NAS Fallon, Fallon, NV
Contract Number N62473-06-D-2206
Task Order Number 0107

Final Meeting Minutes Remedial Project Manager Meeting

**Conference Room, Environmental Department, Building 307, NAS Fallon, Fallon, NV
Naval Air Station Fallon
Fallon, Nevada**

October 6, 2011

Hot Pit #3 SI Results - Groundwater

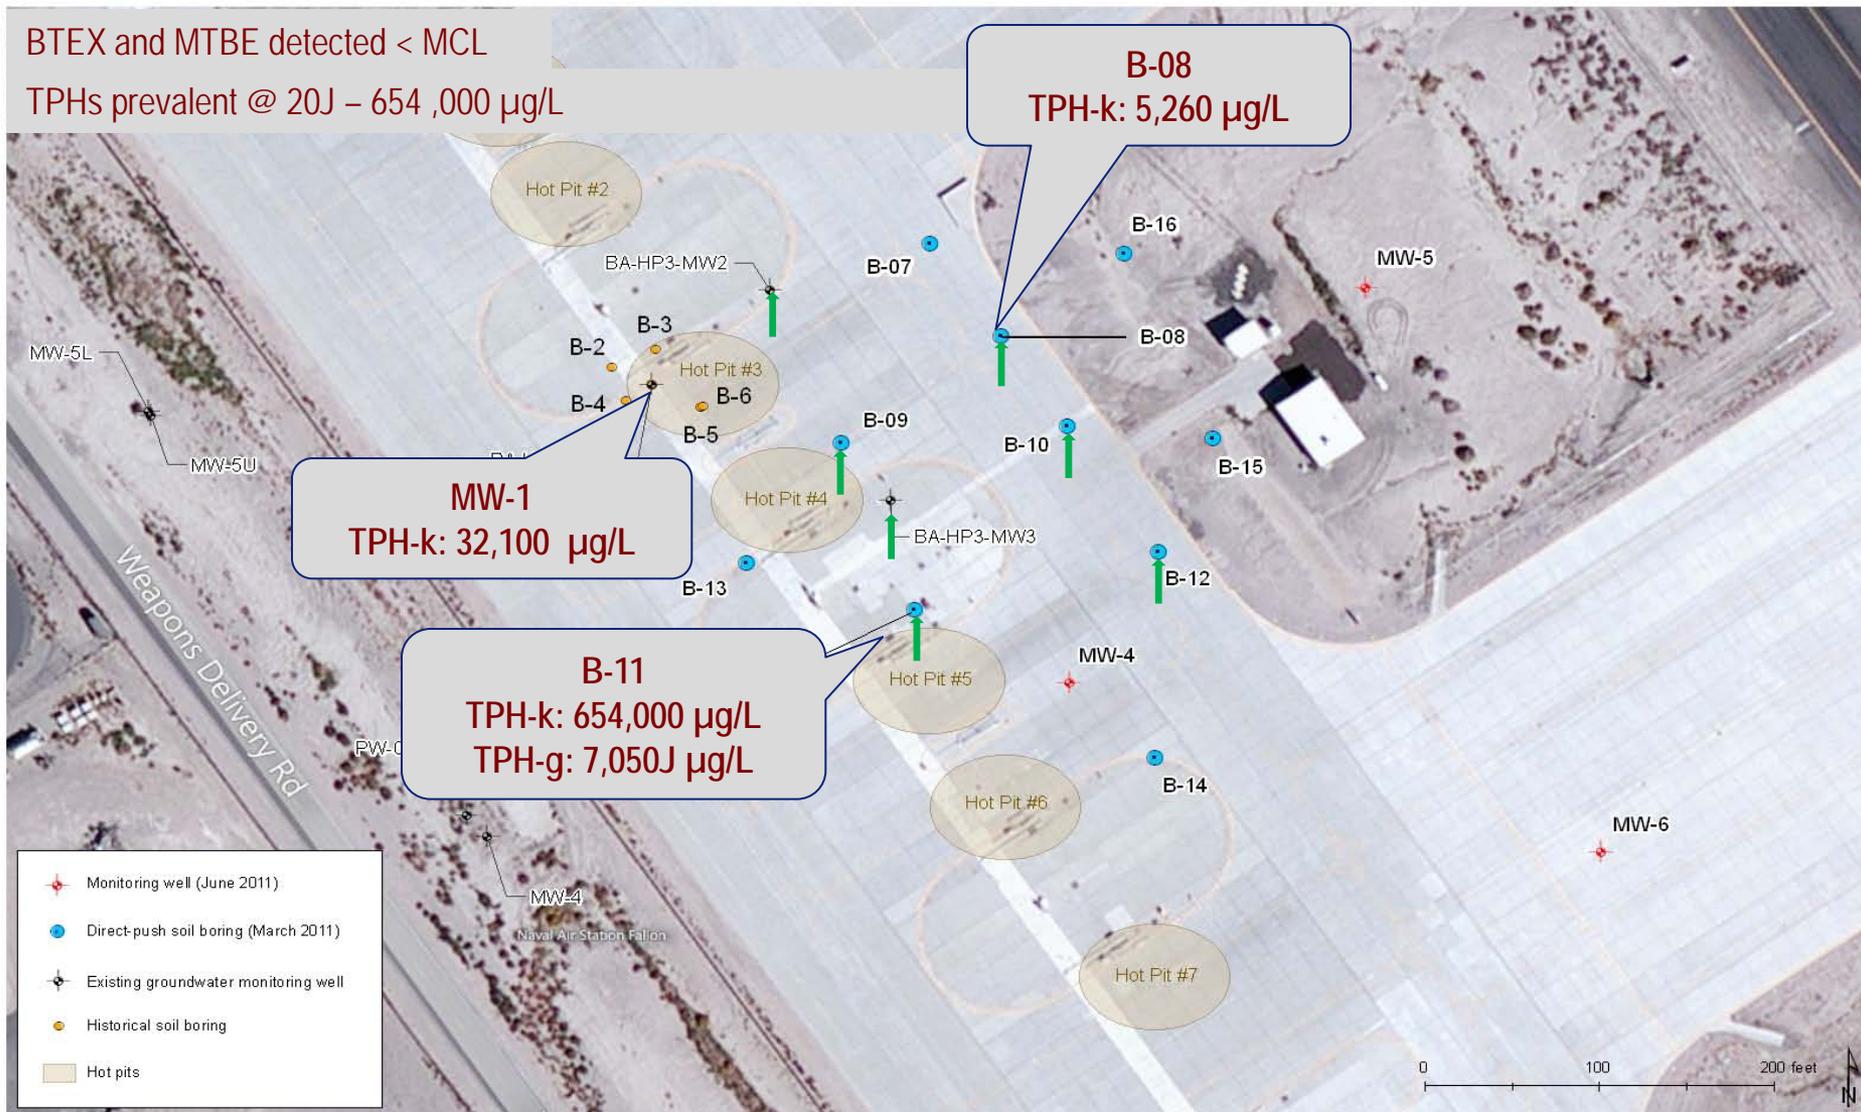
Slide #6: Hot Pit #3 groundwater results – NDEP Comment: MW-6, which is the downgradient well, did not show anything different from MW-5. Were the pipes pressure-tested, since there is suspected leaking due to high concentrations of TPH?

Navy Response: All three new groundwater monitoring wells (MW-4 through MW-6) have the same concentrations of TPH-k (110 µg/L) and were “not detected” (ND) for other chemicals, which indicate commingled contamination from several historical releases, rather than only from Hot Pit #3. The base conducts pressure-testing of the pipes each year, and the pipes are not currently leaking. Analytical results of the grab groundwater samples at the boring locations can be skewed up by the fines in the samples.

Site 18 – Supplemental Site Investigation

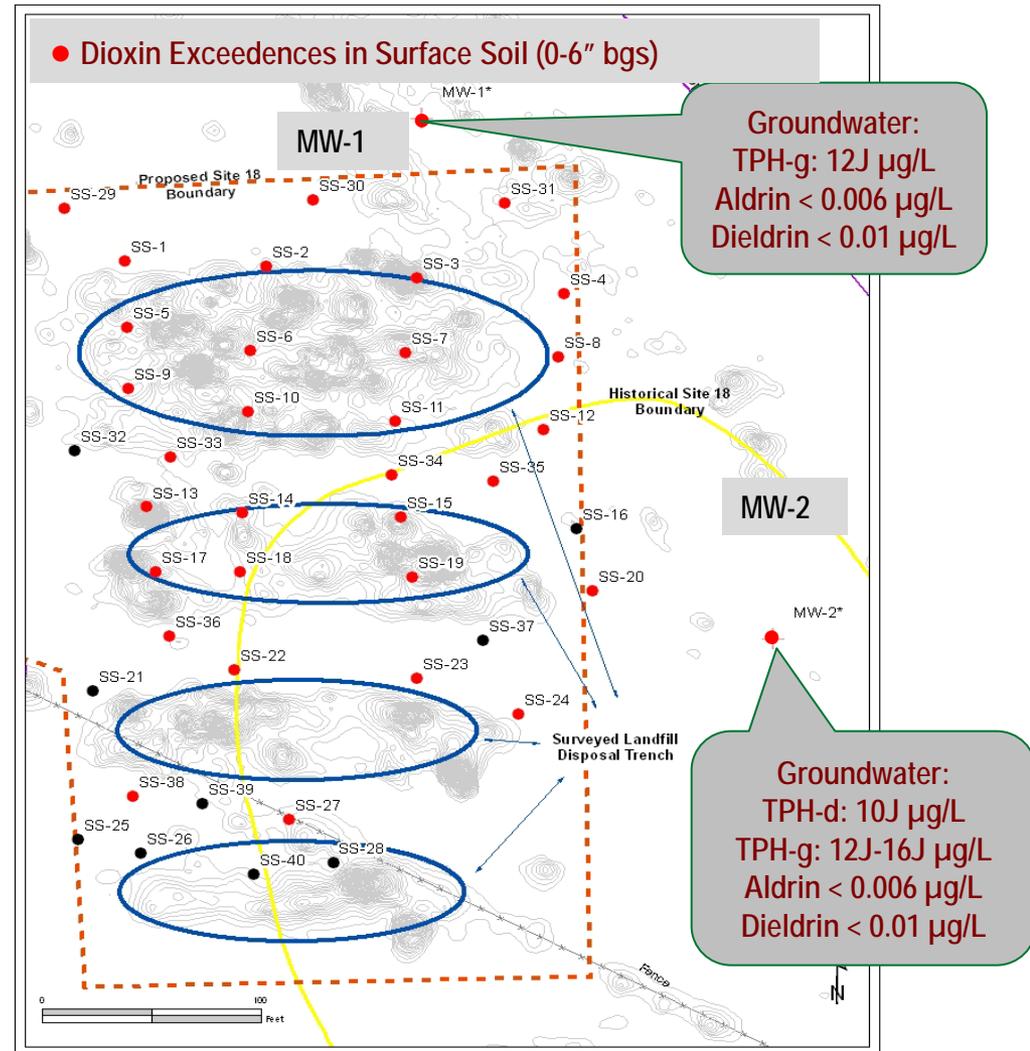
Slide #10: Site 18 soil results – NDEP Comment: Were there burning activities happening at the site which caused the elevated dioxin levels?

Navy Response: The depths of the disposal trenches are not defined. If there were burning activities, a full suite of dioxins would be expected to be detected in the analytical results. Since there are exceedances of only two dioxins, the source may be from the pesticides used and disposed at the site. In the FFS, remedial alternatives, including a complete excavation of the landfill, will be evaluated. Mr. Javaherian added that he did a back of the envelope calculation using the maximum detections of the two exceeding dioxins and the calculated risk was at the level of 10^{-5} under residential land use scenario, and slightly over 10^{-6} under industrial/commercial land use scenario. Both of these risk values are within the risk management range. And if we would do a calculation using the 95% UCL concentrations, the risks would be even lower.

Results – Floating Product/Soil Smear Zones

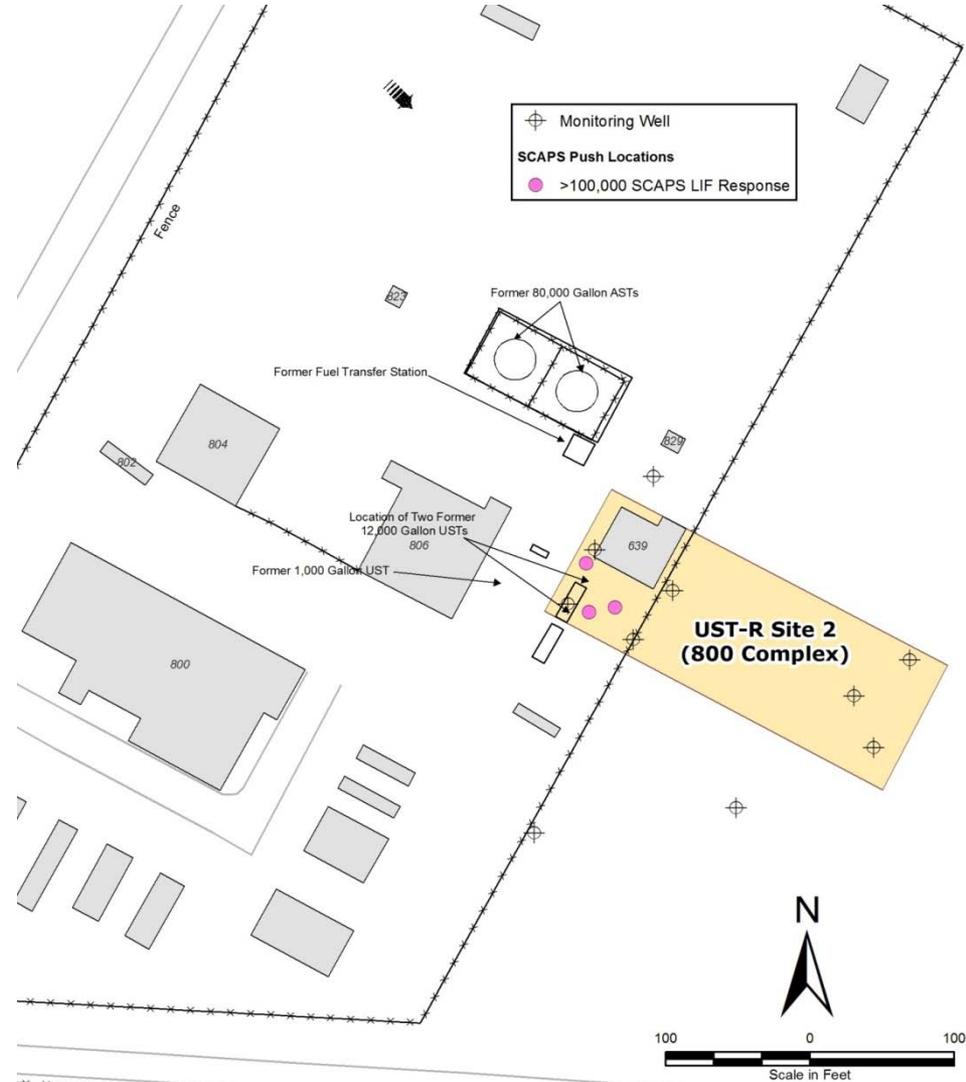
Slide #17: Results of Floating Product/Soil Smear Zones, UST-R Site 1 – NDEP Comment: It is a gasoline tank; why is the free product in the subsurface mainly diesel?

Navy Response: Both gasoline and diesel were stored at the site.

Results – Floating Product/Soil Smear Zones

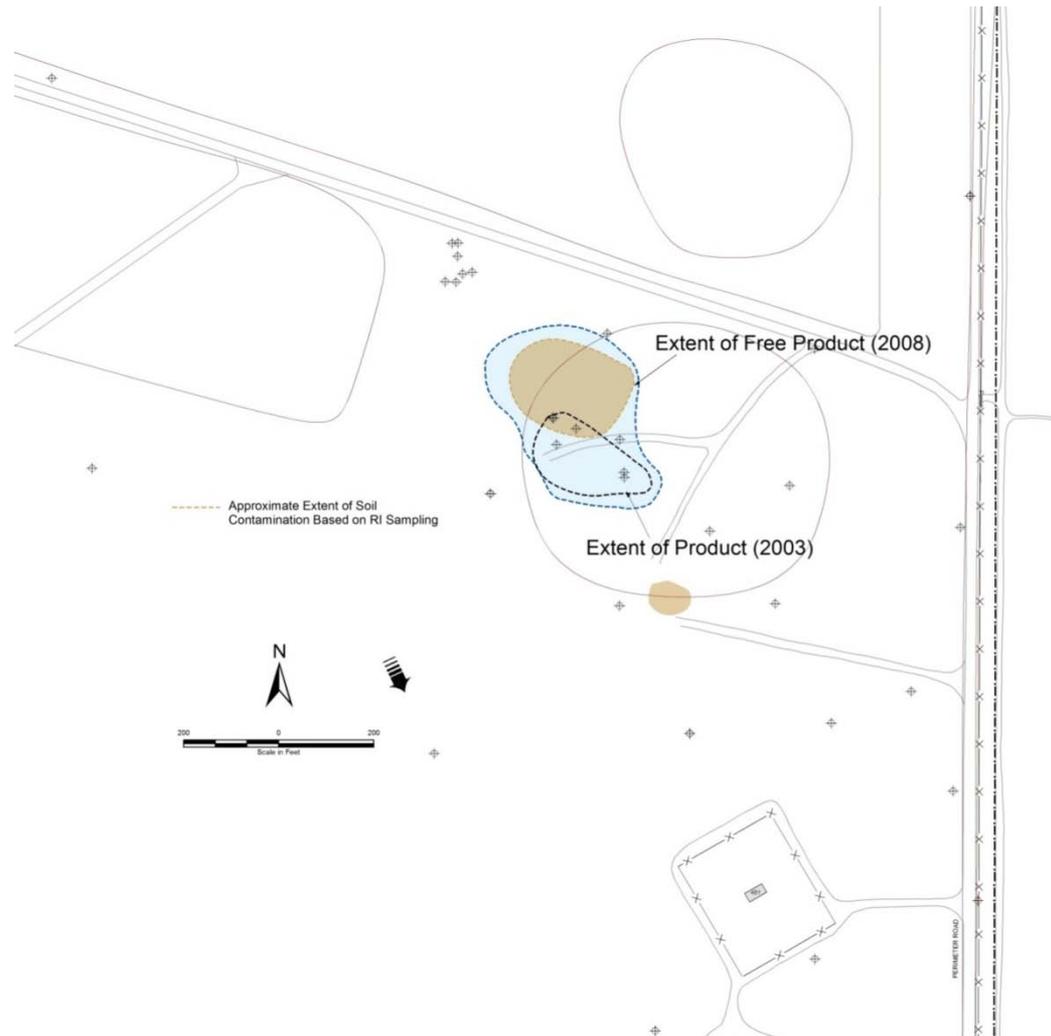
Slide #18: Results of Floating Product/Soil Smear Zones, UST-R Site 2 – NDEP Comment: Is the free product in the subsurface also mainly diesel?

Navy Response: Both gasoline and diesel compounds are found in the subsurface at this site.

Results – Floating Product/Soil Smear Zones

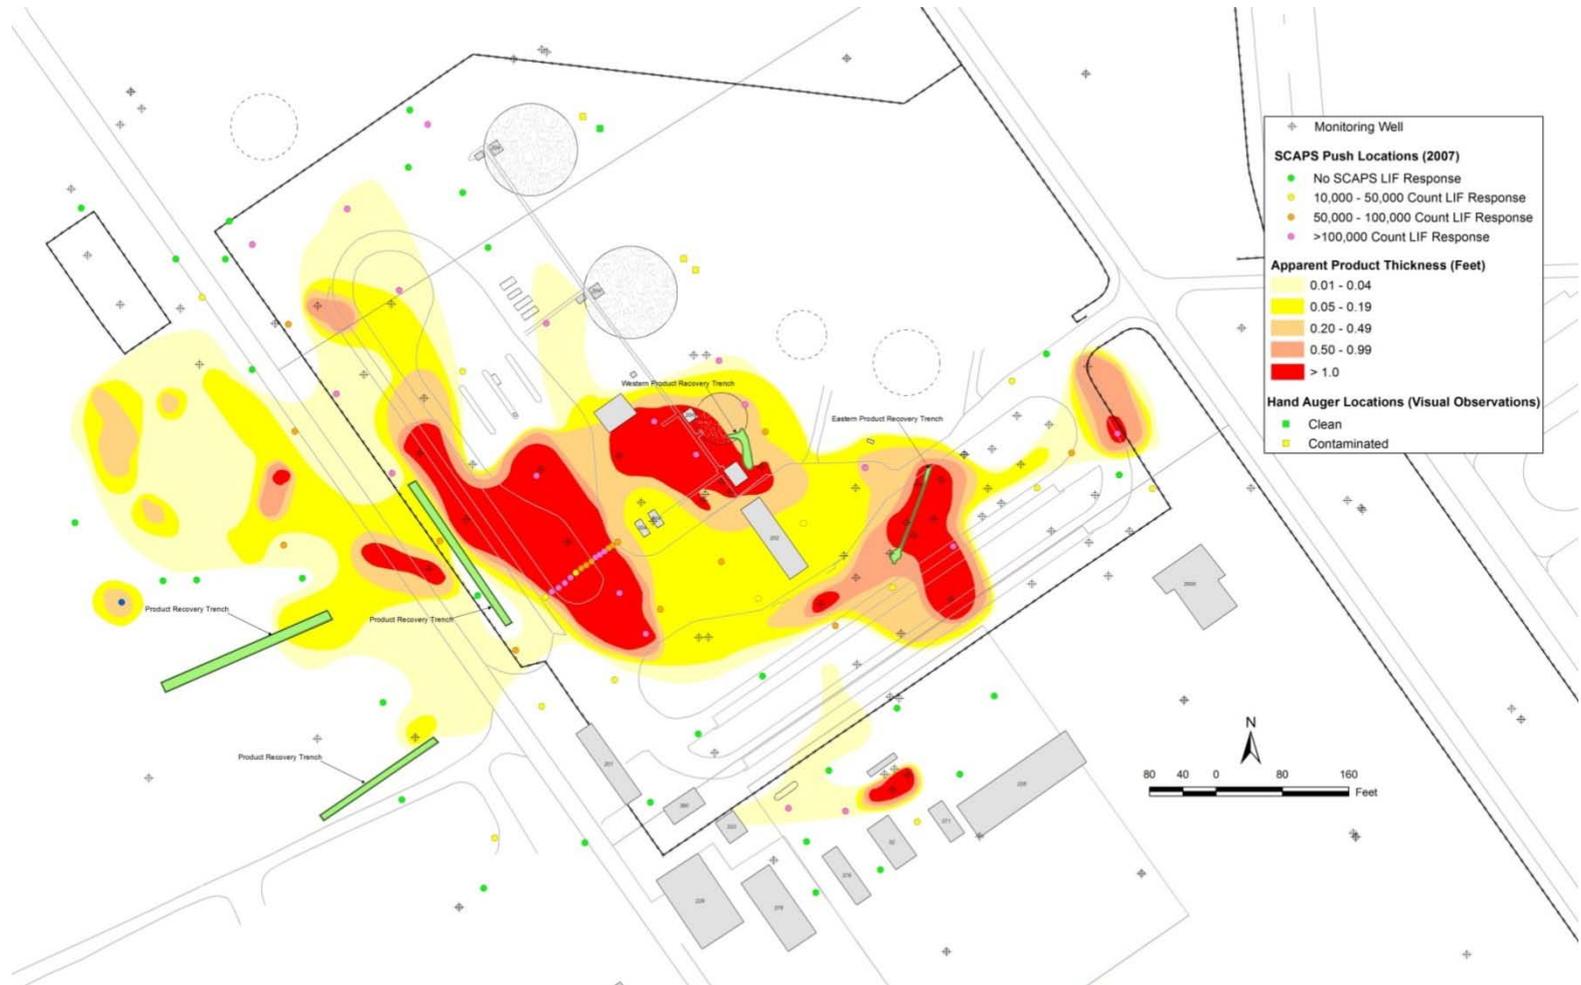
Slide #19: Results of Floating Product/Soil Smear Zones, Site 6 – NDEP Comment: Is the free product in the subsurface also mainly diesel? Was a soil gas survey also performed at this site?

Navy Response: Topsoil at the site is very soft, and the groundwater table is approximately 7 to 8 feet bgs. Site Characterization and Penetrometer System (SCAPS) was unable to gain access to the site at the time of investigation. However, prior to the SCAPS investigation, a passive soil gas survey was conducted at Site 6 in August 2006 to screen for fuel-related compounds. About 0.5 foot of floating product was found and is mainly composed of Jet Fuel #5.

Results – Floating Product/Soil Smear Zones

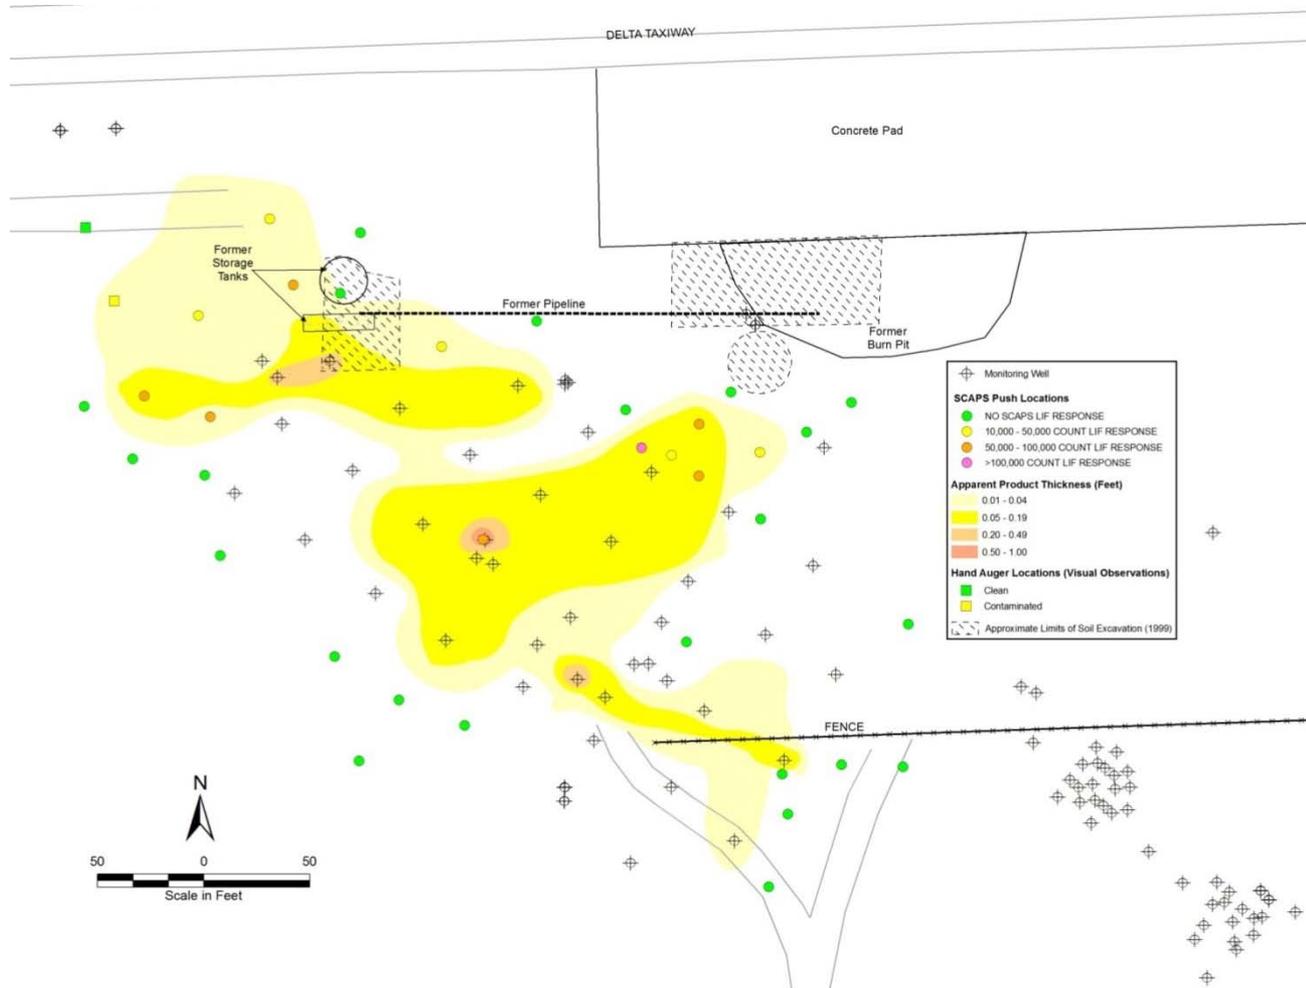
Slide #20: Results of Floating Product/Soil Smear Zones, Northern OU Sites 2 and 4 – Navy Comment: The Navy removes free product from 25 wells with skimmers every week and has removed about 3,200 gallons during the last couple of years. These two sites will be kept as IR sites. Recommendations made in the RI for these two sites are to monitor the plume and verify that the free product is not migrating offsite. Even groundwater monitoring wells at the sites do not show elevated BTEX concentrations, so the free product in soil has been stable for the last 20 years also and is less likely to migrate offsite now.

Results – Floating Product/Soil Smear Zones

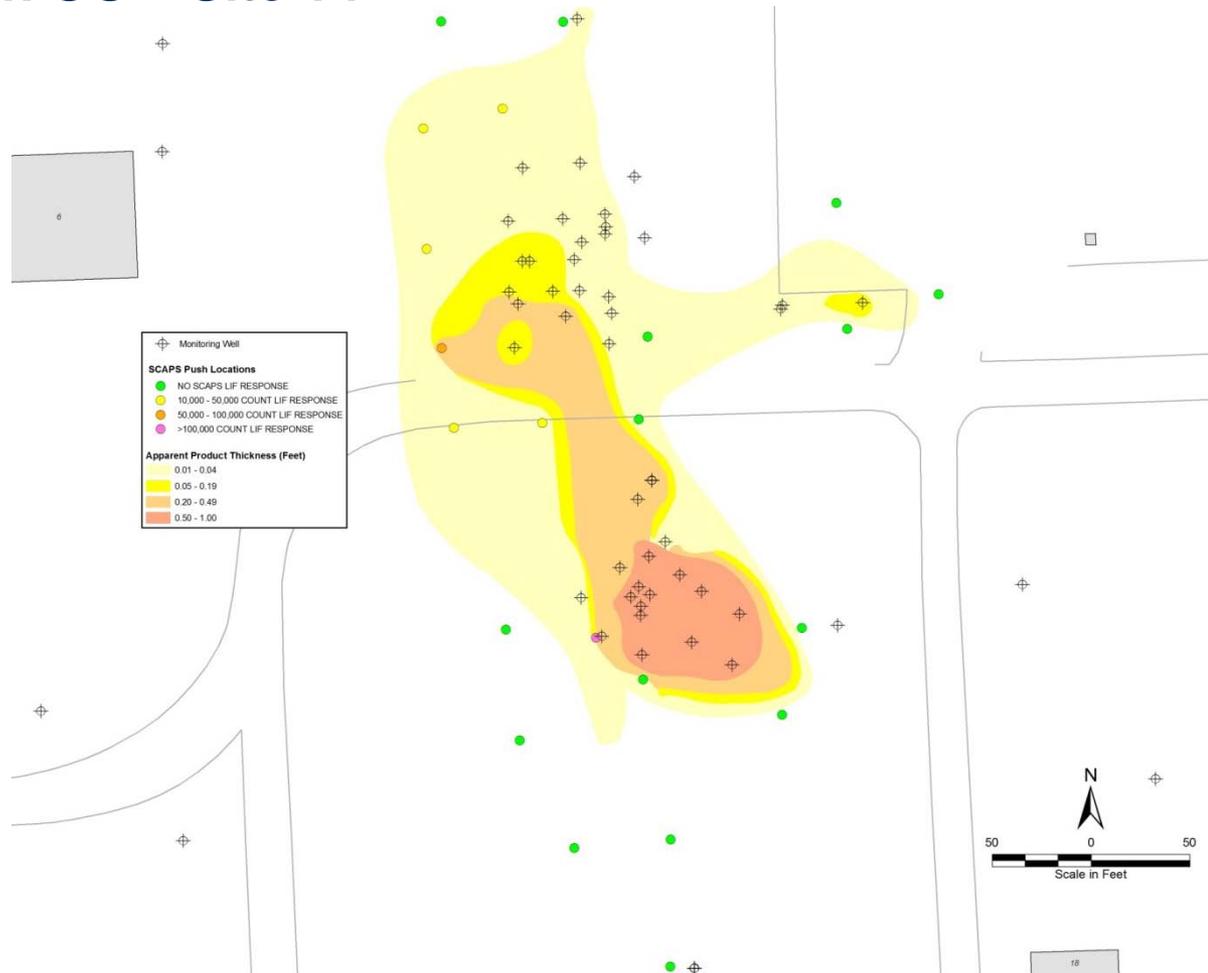
Slide #21: Results of Floating Product/Soil Smear Zones, Northern OU Site 1 – Navy Comment: An approximately 0.5-foot-thick layer of free product (identified as Jet Fuel #5) was observed in 20 to 30 wells. Approximately 900 gallons of free product have been removed from the site. The wells shown at the lower right corner of the slide are pilot study wells. Surface soil at this site was removed in the past due to contamination by dioxins.
